A21 / A205 Catford Town Centre

Do Maximum Option 2

Stage 1 Road Safety Audit

Ref: 3981/007/A205/TLRN/2022

3.2 DRAWING NO. PJ569C-RSM-FEA-07-SK-TE-01-0001

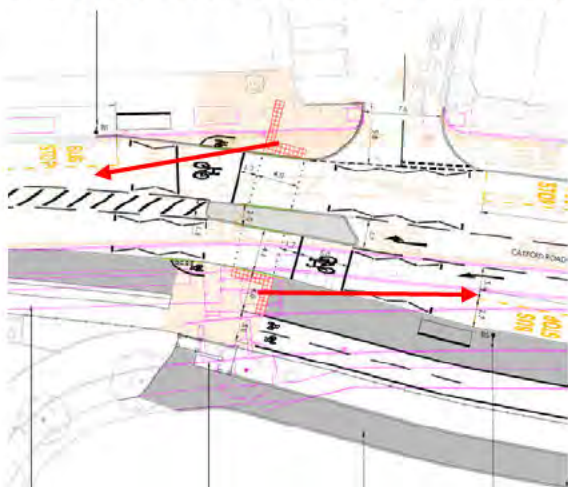
Location: A1 – Catford Road, New Toucan crossing outside of the station.

Summary: Stationary buses may obstruct intervisibility between pedestrians / cyclists waiting at the crossing and road users approaching the crossing. This could increase the risk of crossing users being struck by opposing traffic.

Bus stops are proposed on the immediate approaches to the new Toucan crossing. Stationary buses may obstruct intervisibility between pedestrians / cyclists waiting at the crossing and road users approaching the crossing. Pedestrians / cyclists crossing out of phase may therefore fail to see or be seen by drivers. This could increase the risk of crossing users being struck by opposing traffic. The problem may be exacerbated by the short length of zig-zag markings which also reduce driver awareness of the presence of the crossing.

It is recommended that suitable visibility is provided to / from the crossing, taking account of stationary buses within the adjacent bus stops and that the length of zig-zag markings is increased to improve awareness of the crossing.

Design Organisation Response	Accepted / Part Accepted / Rejected
<p>The location of the proposed crossing is very constrained.</p> <p>The existing bus stops either side of the proposed crossing are very busy with 41bph both east and westbound in the peaks. Increasing the length of the zig-zag markings would require the bus stops to be relocated or the cages to be extended or curtailed. There is no scope to extend the cage length. Reducing the length of the bus stop cages would not reduce the number of buses stopping but would force buses to stop outside the stop extents on the approaches to the stops and may cause issues at these locations or problems for passengers seeking to board or alight. Similarly there is no scope to relocate the stops away from the crossing owing to the bridge over the railway line to the west of Doggett Road and the close proximity of Ravensbourne Park to the west and Nelgarde Road to the east. Removing the bus stops would remove a key interchange. The closest stops are currently 200m to the east and 300m to the west. Those to the east are proposed to be relocated as part of</p>

this scheme and will then be 325m away.

The design has been reviewed and the visibility on the northern kerb to eastbound traffic has been increased to 28m and to 30m on the southern kerb to westbound traffic (the visibility has been measured from a point 0.5m back from the kerb at the studs closest to the oncoming traffic to a point 1m off the bus stop cage).

Agree with the designer's response & proposed amendments. Although the design is very tight for accepted minimum design parameters, a crossing at this location is a significant improvement on no crossing at all in light of it being a known desire line with a pedestrian collision history.

Location: A3 – Catford Road j/w Doggett Road.

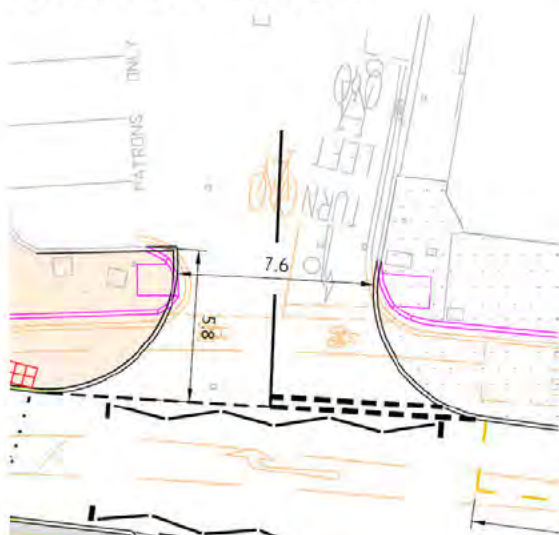
Summary: A lack of a pedestrian crossing may increase the risk of pedestrian trips and falls.

The removal of the existing uncontrolled pedestrian crossing is planned as part of the junction buildout however, no replacement dropped crossing is proposed. A lack of appropriate dropped crossing facilities for pedestrians may increase the risk of trips and falls over raised kerbs.

It is recommended that suitable pedestrian provision is provided at the junction.

Design Organisation Response	Accepted / Part Accepted / Rejected
Appropriate dropped kerbs and tactile paving added	
Client Organisation Comments	
Agree with Designer's response and design amendments.

Location: B2 – Catford Road eastbound junction with Thomas’ Lane; new pedestrian/cycle link

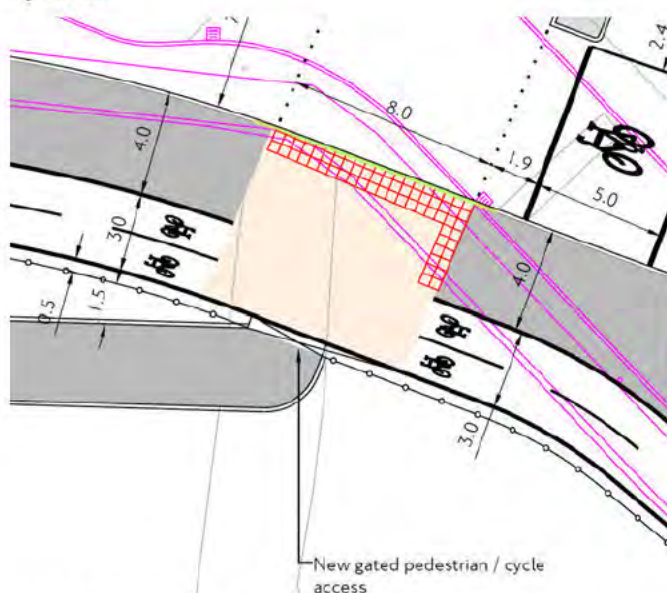
Summary: Restricted visibility between opposing pedestrians and cyclists may increase the risk of collisions between pedestrians and cyclists.

A fence and gate are proposed between the cycle track and new gated pedestrian / cycle access. There is concern that the horizontal alignment of the connection to the new access into the cycle track could be difficult for cyclists travelling west to south to negotiate and that the gate and fence could further exacerbate this issue by reducing forward visibility. This may increase the risk of collisions between pedestrians and cyclists.

It is recommended that suitable geometry is provided to allow west to south cyclists to access the facility and that the fence and gate are located behind the junction visibility splays.

Design Organisation Response	Accepted / Part Accepted / Rejected
Client Organisation Comments	
The fence and gate have been set back to allow pedestrians and cyclists to wait within the playing field area for an opportunity to cross the cycle track or for the gate to be opened. The fence has been set back to allow a 17m visibility splay (the SSD for 20kph from LTN 1/20) to and from the cycle track at a distance 2.4m back from the track. This will however require an additional 43m ² of land from St Dunstan’s College.	
Agree with designer’s response and proposed design amendments.

3.4 DRAWING NO. PJ569C-RSM-FEA-07-SK-TE-01-0003

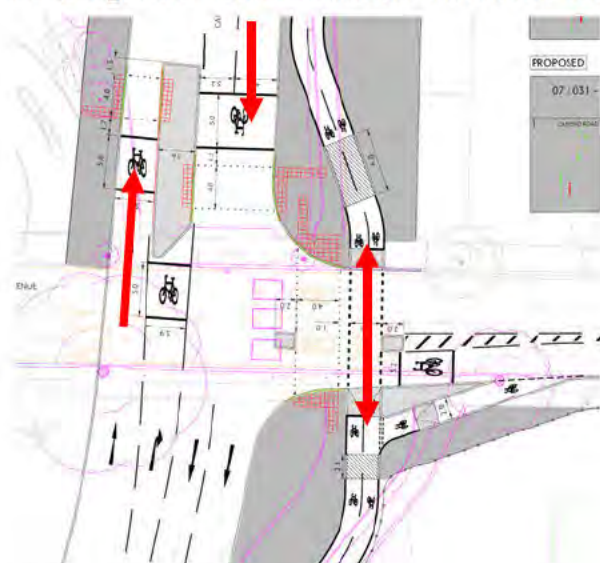
Location: C1 – Catford Road junction with Canadian Avenue.

Summary: Cyclists may stay on the carriageway rather than use the segregated facilities if it is perceived to be a quicker / more direct route. This could increase the risk of collisions between cyclists and general traffic.

The proposed method of control requires east / westbound cyclists to proceed with pedestrians rather than with traffic travelling in the same direction. While the signal timings at this stage are unknown, it is likely that east / westbound general traffic will receive more green time than pedestrians and cyclists. As a result, some cyclists may instead choose to stay on carriageway rather than utilise the segregated facilities as it could be quicker and more direct. Cyclists staying on carriageway may be at a greater risk of collisions with motor vehicles.

It is recommended that the signal staging / green timing given to cyclists is equivalent to that afforded to general traffic travelling in the same direction to ensure that the cycle facilities are given a similar level of priority and to encourage their use.

Design Organisation Response	Accepted / Part Accepted / Rejected
<p>Giving cyclists the same green timing as general traffic travelling in the same direction has been discussed with Network Performance and although not modelled it is anticipated that this would create extensive delays for general traffic, including buses, at this junction. This may result in queuing through the closely associated junctions to the east and west and may result in conflicts at those junctions. In addition it is likely that a longer cycle time would be required which would increase delays for all junction users, including pedestrians and cyclists. With longer wait times pedestrians may be more likely to cross against the red man increasing the risk of conflict with vehicles.</p> <p>The east-west cycle facility proposed as part of this scheme runs only from Sangley Road in the east to the rail bridge in the west. The highway over the bridge and to the west of the scheme is not ideal for cyclists and it envisaged that only confident cyclists would use the corridor. These cyclists may not use the proposed facility</p>

owing to the limited length and the delays which would be incurred joining and leaving the facility. The facility has been included in this scheme to protect the space for a future proposal (not part of this scheme and not funded) to provide a pedestrian and cycle bridge to the south of the existing rail bridge which would link into the popular Ravensbourne Link, part of NCN Route 21.

To assist east-west cyclists who do not use the off carriageway facility appropriate lane widths, ASLs and passing width at bus stops has been included in the carriageway design.

3.5 DRAWING NO. PJ569C-RSM-FEA-07-SK-TE-01-0004

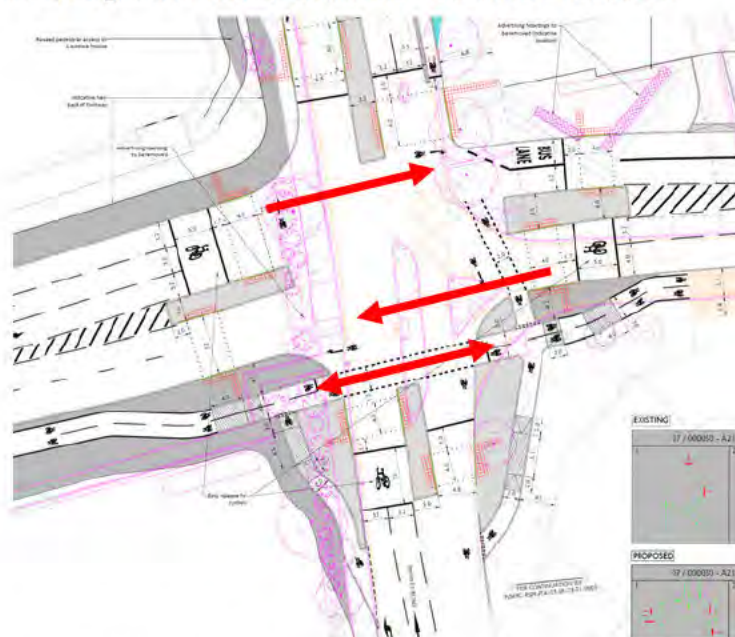
Location: D1 – Catford Road junction with Bromley Road.

Summary: Cyclists may stay on the carriageway rather than use the segregated facilities if it is perceived to be a quicker / more direct route. This could increase the risk of collisions between cyclists and general traffic.

The proposed method of control requires east / westbound cyclists to proceed with pedestrians rather than traffic travelling in the same direction. While the signal timings at this stage are unknown, it is likely that east / westbound general traffic will receive more green time than pedestrians and cyclists. As a result, some cyclists may instead choose to stay on carriageway rather than utilise the segregated facilities as it could be quicker and more direct. Cyclists staying on carriageway may be at a greater risk of collisions with motor vehicles.

It is recommended that the signal staging / green timing given to cyclists is equivalent to that afforded to general traffic travelling in the same direction to ensure that the cycle facilities are given a similar level of priority and to encourage their use.

Design Organisation Response	Accepted / Part Accepted / Rejected
<p>Preliminary modelling suggested that this junction was over-capacity and significant changes (including replacing straight across pedestrian crossings with staggered facilities) were made to reduce delays and minimise the cycle time for all road users, including pedestrian and cyclists. Giving cyclists the same green timing as general traffic travelling in the same direction has been discussed with Network Performance and although not modelled it is anticipated that this would create extensive delays for general traffic, including buses, at this junction. In addition it is likely that a longer cycle time would be required which would increase delays for all junction users, including pedestrians and cyclists. With longer wait times pedestrians may be more likely to cross against the red man increasing the risk of conflict with vehicles.</p>	<p><u>East-west cyclists do benefit from a straight across link rather than being forced to</u></p>

use the staggered facility provided for pedestrians.

The east-west cycle facility proposed as part of this scheme runs only from Sangley Road in the east to the rail bridge in the west. The highway over the rail bridge at Catford stations and to the west of the scheme is not ideal for cyclists and it envisaged that only confident cyclists would use the corridor. These cyclists may not use the proposed facility owing to the limited length and the delays which would be incurred joining and leaving the facility. The facility has been included in this scheme to protect the space for a future proposal (not part of this scheme and not funded) to provide a pedestrian and cycle bridge to the south of the existing rail bridge which would link into the popular Ravensbourne Link, part of NCN Route 21.

To assist east-west cyclists who do not use the off carriageway facility appropriate lane widths, ASLs and passing width at bus stops has been included in the carriageway design.

3.9 DRAWING NO. PJ569C-RSM-FEA-07-SK-TE-01-0008

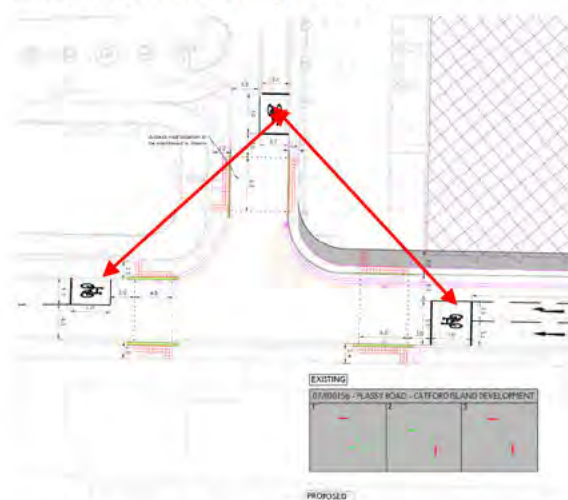
Location: F1 – Plassey Road junction with Catford Island Retail Park

Summary: Reduced junction inter-visibility could result in collisions between pedestrians and opposing traffic.

Junction intervisibility is restricted by the property boundaries and the setback alignment of the crossing carpets. Drivers of vehicles turning through the junction may not be able to see or be seen by pedestrians using the crossings. This could increase the risk of collisions between turning traffic and pedestrians. It is appreciated that this is in part an existing problem for traffic on the northern and western arms of the junction.

It is recommended that junction intervisibility is maximised. This could be achieved by relocating the crossings closer to the junction and narrowing the crossing carpets

Design Organisation Response	Accepted / Part Accepted / Rejected
<p>The junction is constrained. Owing to the swept paths of vehicles entering and exiting the site the stop lines must be set back to ensure turning vehicles do not conflict with vehicles waiting at the stop lines.</p> <p>If the location and width of the pedestrian crossing were limited to the junction intervisibility zone the pedestrian crossings would be very narrow.</p> <p>To mitigate this Problem the crossing on the northern arm of the junction has been moved south into the junction while the crossing on the western arm of the junction has been narrowed. The offset between the pedestrian studs and the cycle stop line on the southern arm is already 3m (from the standard 1.7m). These changes should reduce the area of limited visibility.</p> <p>However these changes result in the distance between the cycle stop line and the pedestrian studs exceeding the standard 3m (1.7m with an ASL). This may result in cyclists and drivers encroaching into the junction, crossing their respective stop lines and being at risk of being struck by turning vehicles.</p> <p>The crossings could be further reduced in width but this would increase the distance between the cycle stop line and the pedestrian crossing exacerbating the risk above.</p>

Pedestrians may also choose to cross between the studs and the vehicle stop lines.

The crossings have not been moved further into the junction as this would place some areas of the crossing on kerb radii. With crossings on kerb radii it can become difficult to correctly locate the pedestrian push button (they can become located slightly behind the main pedestrian crossing where they may not be expected by visually impaired pedestrians). The crossing length is also increased resulting in pedestrians being in the carriageway for longer with greater exposure to vehicles. Increased crossing lengths also increase the crossing times which can impact junction operation and result in longer wait times for pedestrians and increased delays for all road users.

The Catford Island site is currently the subject of redevelopment plans. Preliminary indications suggest that this junction will be removed. It is proposed that this Problem be reviewed again at Concept Design when details of the redevelopment will be better understood.

3.10 DRAWING NO. PJ569C-RSM-FEA-07-SK-TE-01-0009

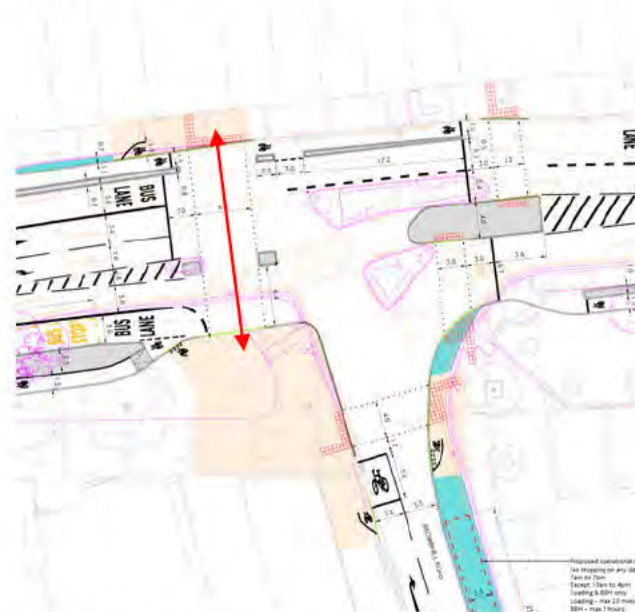
Location: G1 – Rushey Green junction with Brownhill Road, split phase signal staging.

Summary: Single stage crossing across split phase traffic movements may result in pedestrians stepping out in front of oncoming traffic.

It is recommended that the signal staging is adjusted to remove the potential misunderstanding. If this is not possible, maximise the distance between the stop line and pedestrian crossing studs to provide increased intervisibility between pedestrians and opposing traffic

Design Organisation Response	Accepted / Part Accepted / Rejected
<p>Amending the signal staging would introduce an opposed right turn (see Problem 3.1.1) or would require the north and southbound traffic movements to run separately. Although not modelled it is anticipated that this latter option would result in delays, queues and require an increase in the cycle time, to the detriment of all road users through the junction.</p> <p>Owing to the proposed staging it is not anticipated that many (if any) pedestrians will cross from east to west to the central island while the right turn is held. The problem will therefore be limited to a small number of pedestrians who may have become trapped on the island following the end of the green man.</p> <p>Increasing the separation between the studs and the stop line sufficiently to provide</p>

Location: I2 – Plassey Road junction with Brownhill Road; south eastern side crossing points.

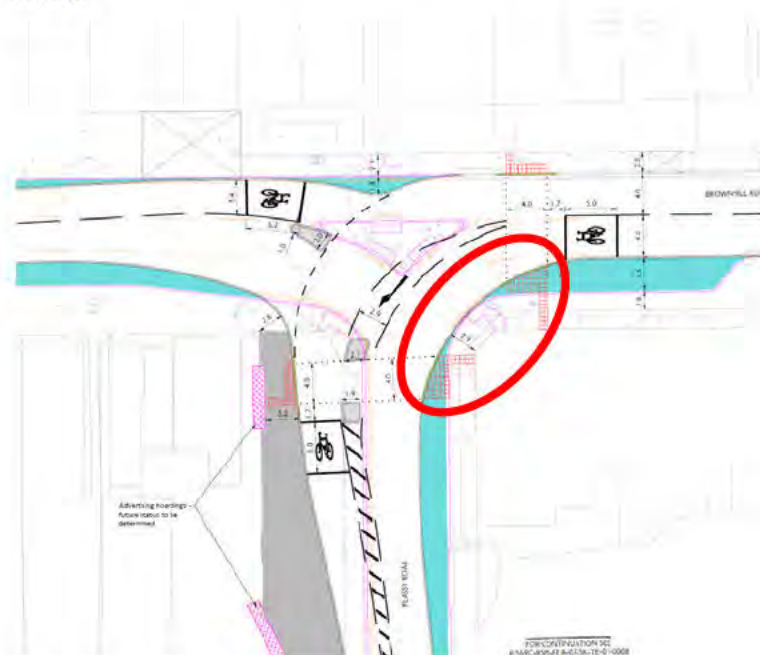
Summary: Crossing points on radius kerbs may increase the risk of collisions involving visually impaired pedestrians.

It is proposed to provide the southern side of the eastern arm crossing and eastern side of the southern arm crossings on a radius kerb. Dropped kerbs on radius curves can cause confusion as to the intended direction of the crossings to visually impaired users. Visually impaired users may approach the crossings and believe them to be perpendicular to the actual direction of the crossing. This can increase the risk of visually impaired pedestrians inadvertently stepping out into the path of opposing traffic.

Design Organisation Response	Accepted / Part Accepted / Rejected
<p>Relocating the pedestrian crossings to ensure they are not provided on radius kerbs will result in a worsening of the junction intervisibility and reduce the ability of drivers turning through the junction to see or be seen by pedestrians using the crossings. This could increase the risk of collisions between turning traffic and pedestrians.</p> <p>Relocating the crossings would also increase intergreens at the junction, increasing lost time and potentially increasing delays for general traffic, including buses. In addition it is likely that a longer cycle time would be required which would increase delays for all junction users, including pedestrians and cyclists. With longer wait times pedestrians may be more likely to cross against the red man which with limited junction intervisibility would increase the risk of conflict with vehicles.</p> <p>Appropriate tactile paving will be introduced to guide visually impaired pedestrians safely through the junction.</p>

Agree with the designer's response. This location is very constrained and amending the design will result in new issues. It is felt, therefore, that the current design presents the best balance of remaining issues and risk.

Location: 4 – Drawing No. PJ569C-RSM-FEA-07-SK-TE-01-0004, north to west cycle lane.

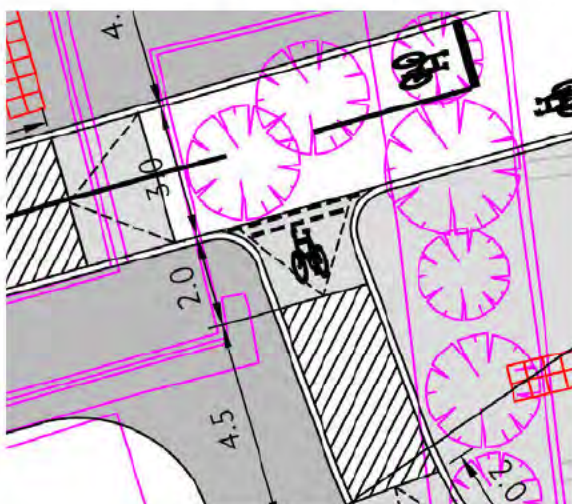
The junction radii for cyclists travelling north to west appears very tight. Cyclists with large cycle types are unlikely to be able to keep their cycles within the confinements of the facilities without obstructing the path of opposing users. It is recommended that a suitable geometry is provided to at the junction for left turning north to west cyclists.

Design Organisation Response	Accepted / Part Accepted / Rejected
Radii increased from 1m to 2m. A larger radius was reviewed but owing to the close proximity of the cycle track and pedestrian crossings a smaller radii was favoured to encourage lower cycle speeds.	
Client Organisation Comments	
Agree with designer's response and proposed design amendments.

Location: 6 – Drawing No. PJ569C-RSM-FEA-07-SK-TE-01-0006, Sangley Road, east of Plassey Road, uncontrolled pedestrian crossing across the mouth of the junction.

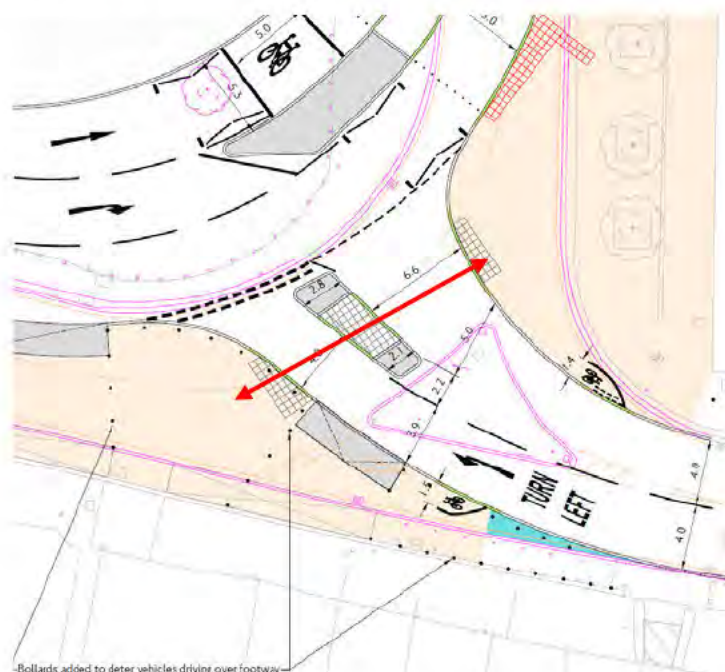
An uncontrolled pedestrian crossing is proposed across the mouth of the Sangley Road priority junction, linking the shared use footway north-south. The width of the refuge island may not accommodate all types of cycle. The uncontrolled nature of the crossing also reduces the continuity of route for cyclists. It is recommended that a dedicated cycle crossing is provided to give greater accessibility and continuity of route for all users.

Design Organisation Response	Accepted / Part Accepted / Rejected
<p>The initial aim was to signalise this junction and provide controlled pedestrian and cycle facilities over Sangley Road however the presence of uncontrolled accesses and existing off carriageway parking meant that this option was not possible. The same private accesses and off carriageway parking preclude the provision of a controlled cycle crossing at this location and to the east along Sangley Road.</p> <p>The proposed island width is 2.2m to 2.6m, sufficient to accommodate a solo upright cycle (1.8m long – LTN 1/20) but insufficient to accommodate a ‘cycle design vehicle’ (2.8m (max) – LTN 1/20). It may be possible to increase the island width but it is anticipated that this would require a significant redesign of the junction and would relocate the proposed signalised crossing to the north.</p> <p>It is proposed that this design be taken to Consultation and the island widened at Concept design if required.</p>

Location: 8 – Drawing No. PJ569C-RSM-FEA-07-SK-TE-01-0011, Merva Court (southern footway adjacent to existing signal-controlled pedestrian crossing).

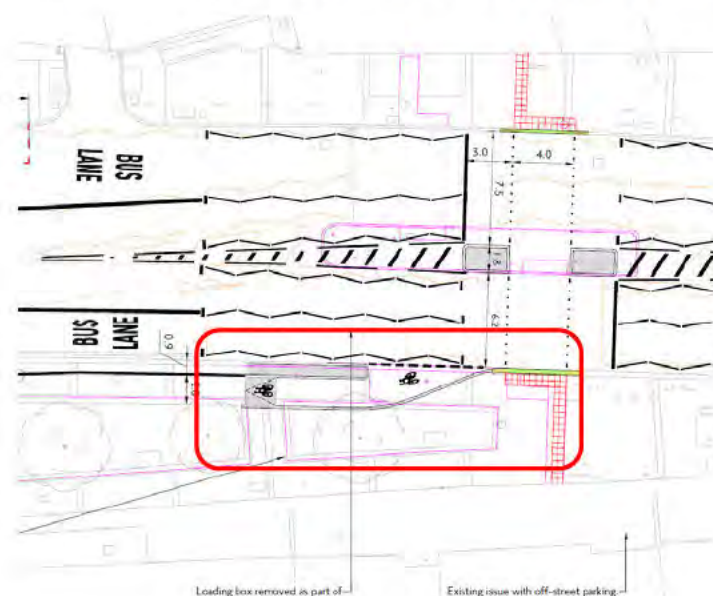
Vehicles appear to be utilising the existing dropped kerb of the controlled pedestrian crossing to access the frontage of Merva Court to park. Within the revised scheme, drivers may enter the new cycle lane pocket to perform the same manoeuvre. It is recommended that measures are provided to either accommodate the vehicle crossover, or physically prevent vehicle access at this location.

Design Organisation Response	Accepted / Part Accepted / Rejected
It is understood that this issue is being addressed as part of a separate scheme. If it has not been addressed at Concept Design it could be incorporated in this scheme.	
Client Organisation Comments	
Agree with designer's response.
